**RE: Main Street Living, LLC
Proposed Mixed-Use Development
and Townhouse Development
Block 1, Lots 31, 33.01, & 34-36
7-9 Main Street &
11-13 Railroad Avenue
Township of Robbinsville
Mercer County, NJ
DEC # 5214-24-00441
Application #R25-03-01**

This letter shall serve as the formal response to the following Township of Robbinsville professional review letters and memorandums:

SCALE: (H) 1"=30'
(V) 1"=10'
SHEET No: 8 OF 31

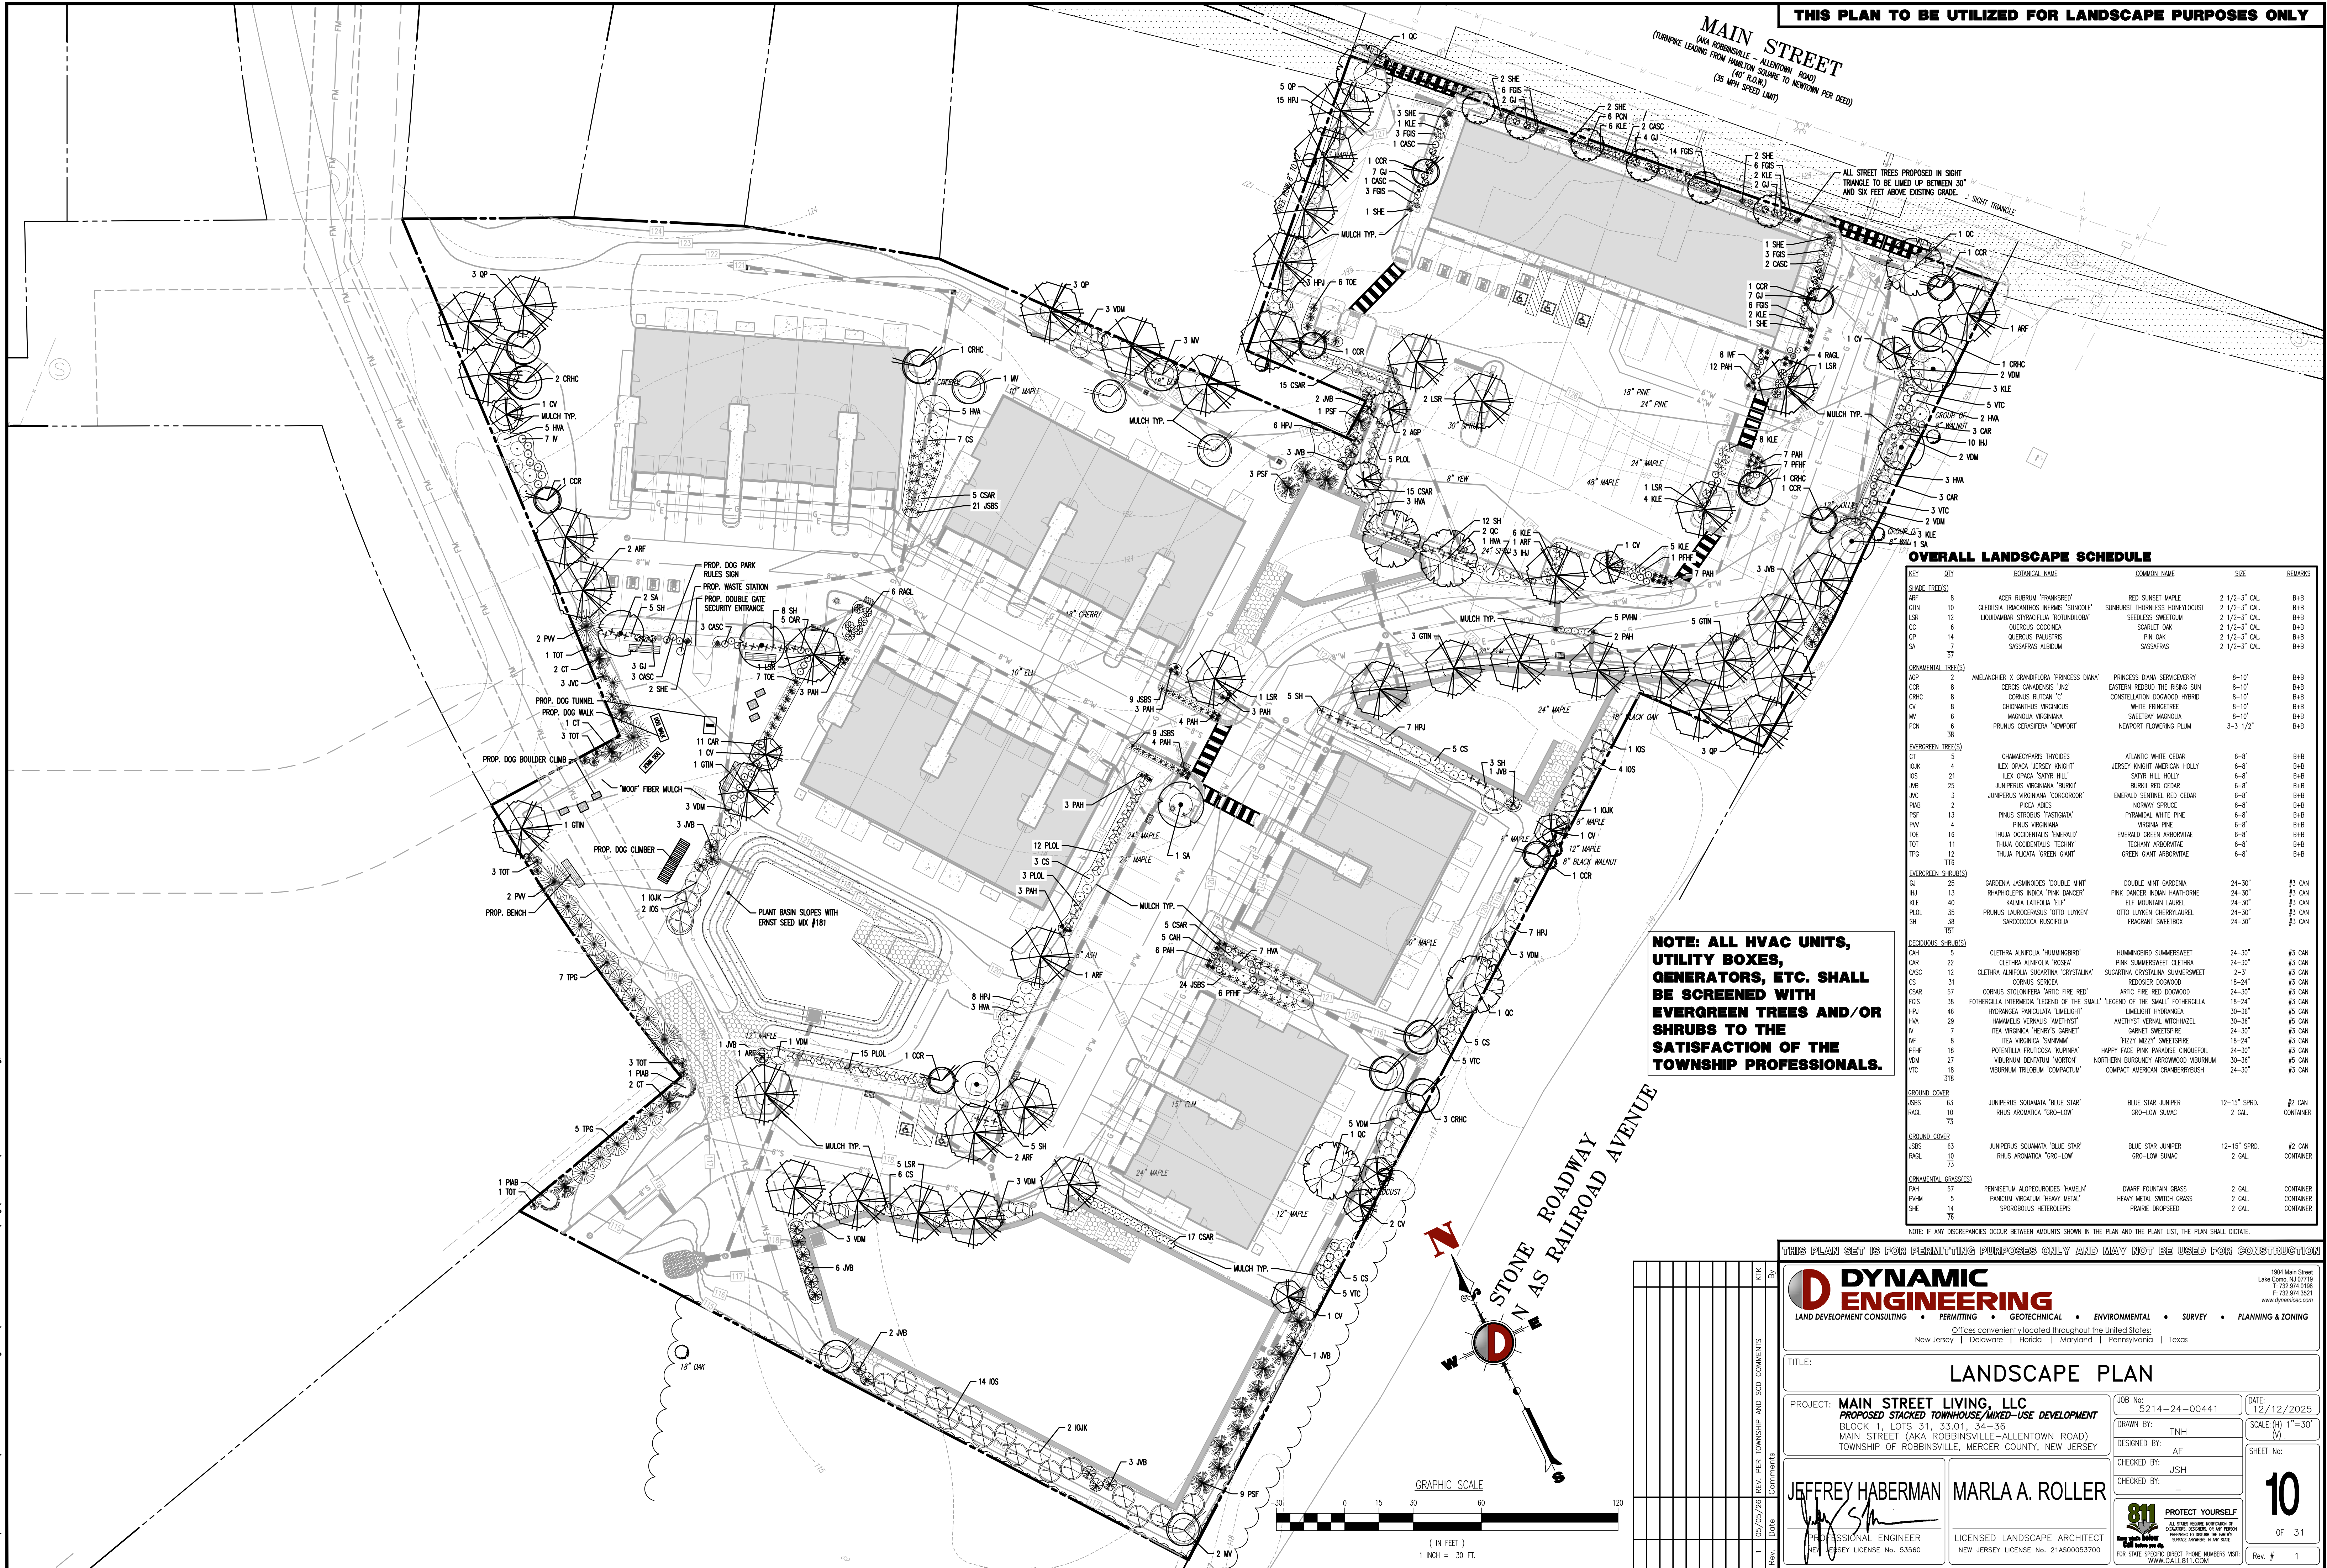
10. *The typical slopes shown on the plans appear to depict pipe conflicts, and the pipe elevations do not appear to match the Pipe Crossing Table. Review and revise the plans for consistency.:*

The Drainage Plan (Sheet 8 of 31) will be revised to provide additional pipe crossing information and locations for concrete encasements as a condition of approval.

DOG PARK

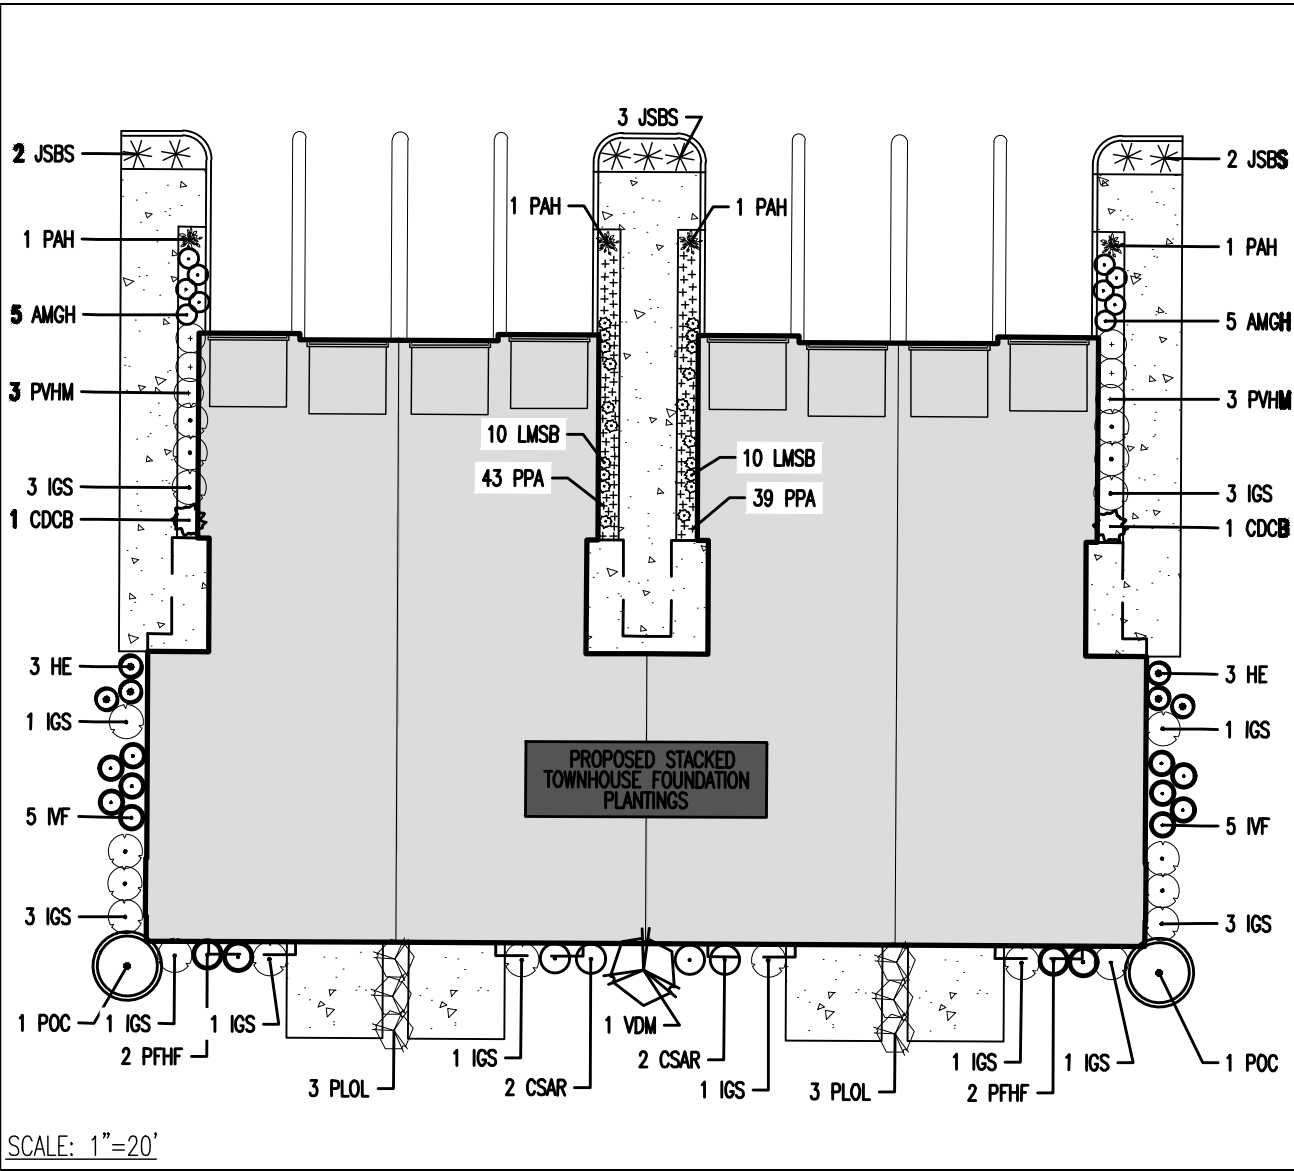
5. *Provide more information and details regarding the proposed amenity space/park.*

A Dog Park and Typical Foundation Plans Detail (Sheet 11 of 31) is provided which contains details and information on the proposed amenity space/park.
